DETAILS

204 S. Dearborn Street

Summary of Request:

Construct addition to rear elevation

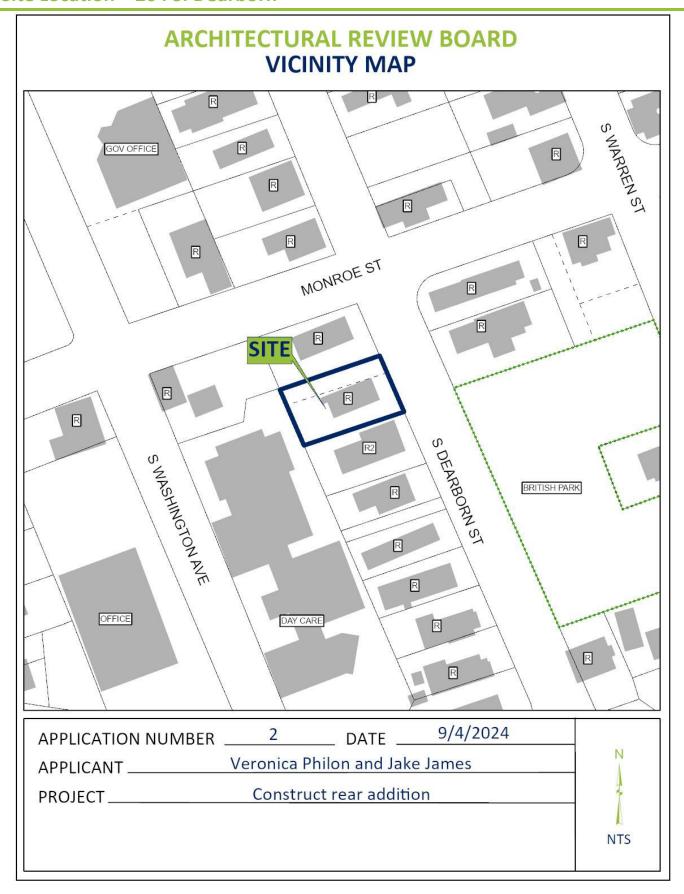
The *Guidelines* call for the placement of an addition to an existing historic structure to appear subordinate to the main structure. The total footprint of the proposed addition and porch, 681 sf, is approximately 80% of the building's current footprint (approximately 839sf). However, the massing created by the original building's upper half-story (for a total of 1380 sf of living space) allows for a one-story extension, placed at the rear, without visually disrupting the building's historic massing. The scale and rhythm of the proposed addition communicates with the original structure in its preservation of consistent ceiling and floor heights, traditional fenestration patterns, and solid-to-void ratios. (6.10,6.11, 6.14,6.15)

The *Guidelines* state that an addition should be clearly differentiated, either by a physical break or an alteration in roofline. (6.12) Although the proposed addition would extend from a non-historic addition, the earlier addition was built on the footprint of an original rear projection. Thus, it may be advisable to either retain the existing corner boards or add similar vertical pieces on the north and south elevations to distinguish the historic massing from the new addition.

The proposed full-width rear porch integrated under the addition's gabled roof, the use of materials and elements such as railings and pickets which echo those of the original front porch, and the matching foundation height all serve to create compatibility between the new porch and this historic workman's cottage. (6.18)

The materials, finishes, and details proposed for exterior walls, porch, roof, fenestration, and foundation of the addition match or complement those of the original historic structure, maintaining its architectural integrity and visual character. (6.13, 6.16, 6.19-6.21)
